Proposal: Demolition of existing 2 storey detached house & construction of a pair of semi-detached replacement dwellings with flood preventative measures.

Site: 4 Lake Lane, Barnham, PO22 0AD.

BN/23/15/PL

Screen Print

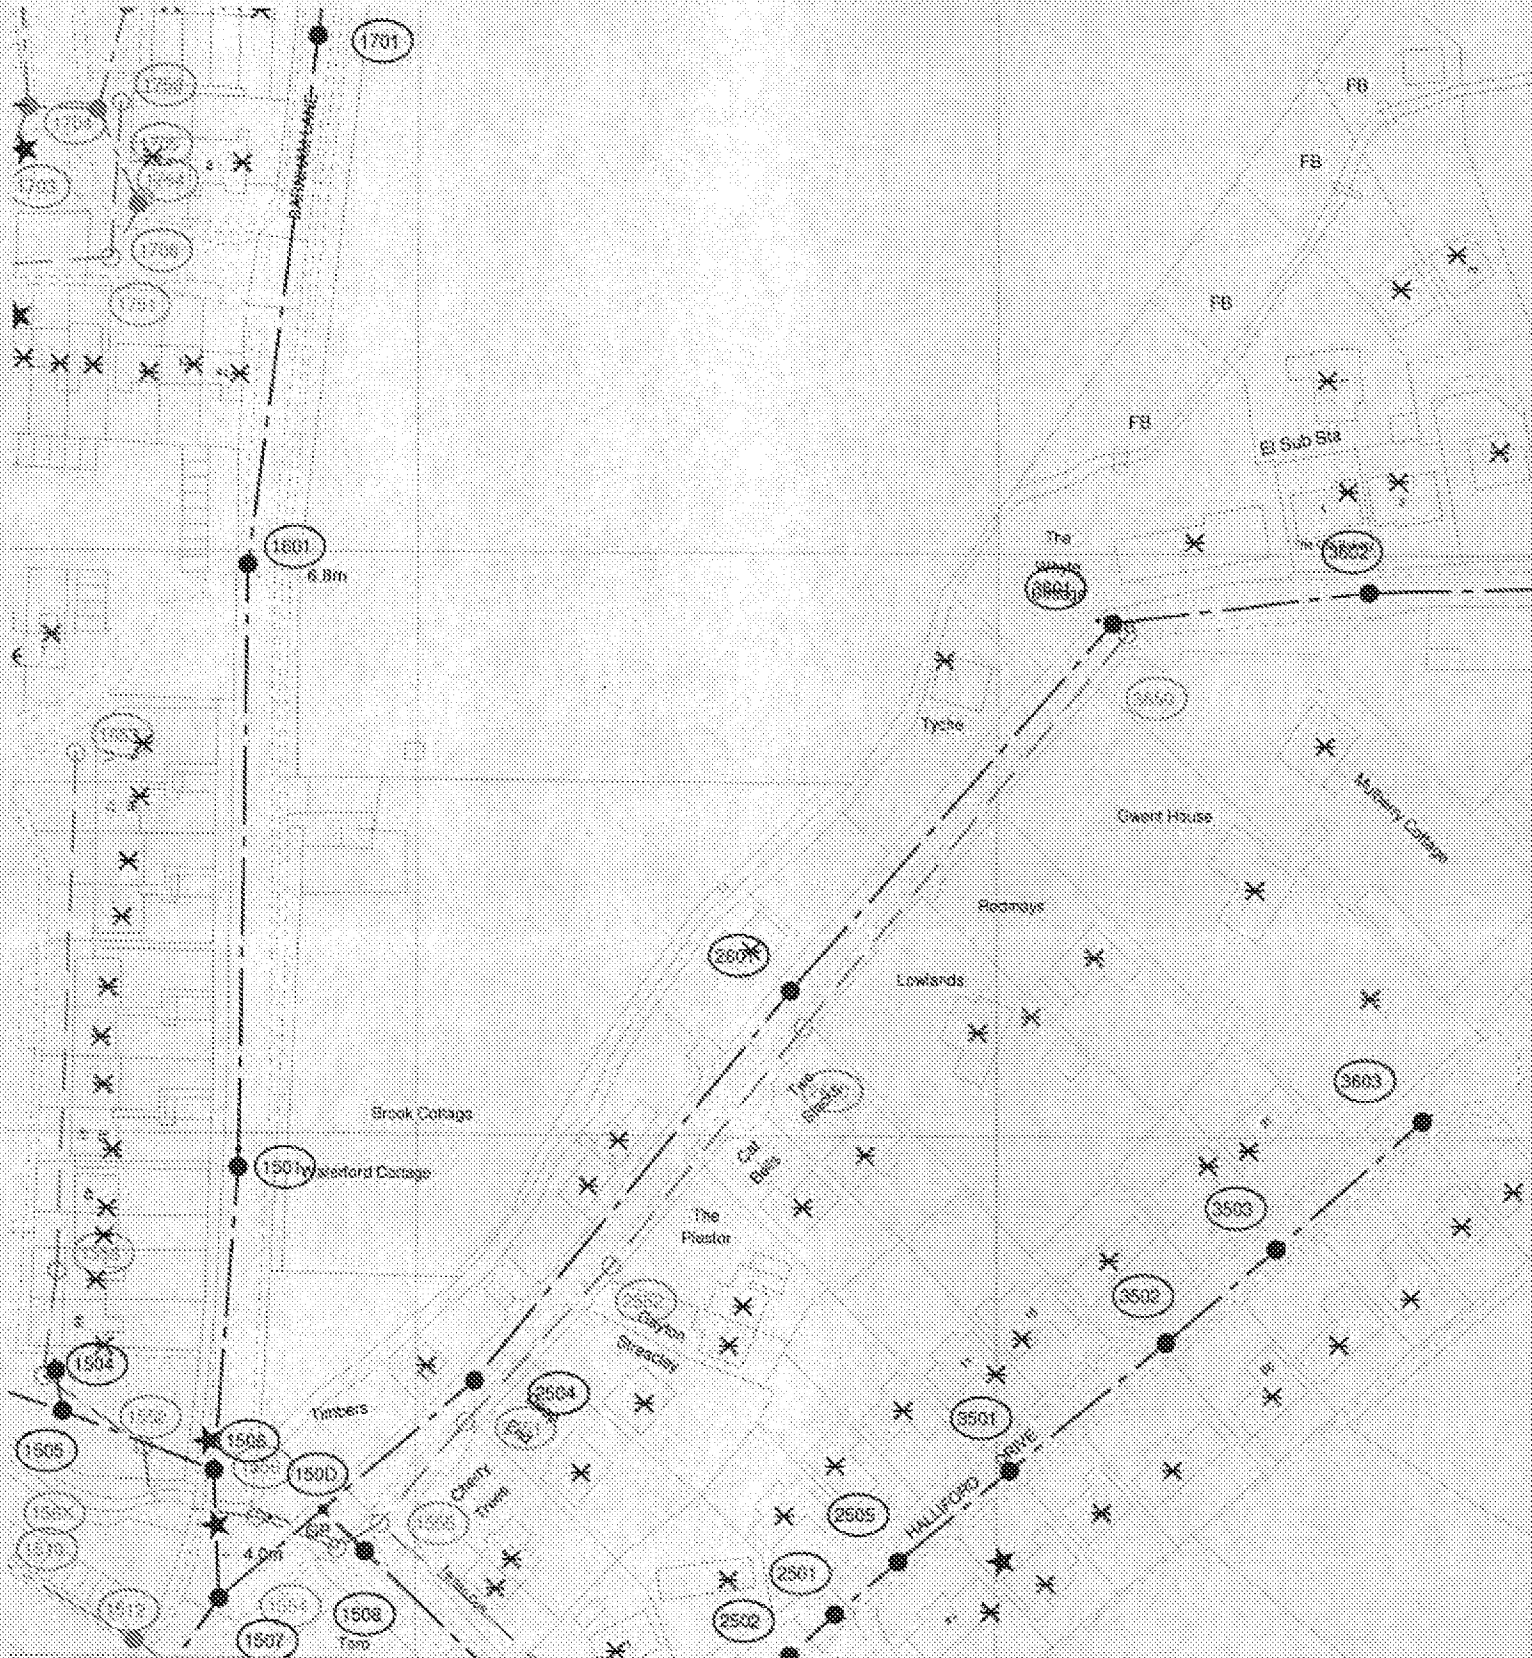
Due to changes in legislation that came in to force on 1st October 2011 regarding the future ownership of sewers it is possible that a sewer now deemed to be public could

be crossing the above property. Therefore, should any sewer be found during construction works, an investigation of the sewer will be required to ascertain its condition, the number of properties served, and potential means of access before any further works commence on site. The applicant is advised to discuss the matter further with Southern Water, Sparrowgrove House, Sparrowgrove, Otterbourne, Hampshire SO21 2SW (Tel: 0330 303 0119) or www.southernwater.co.uk.
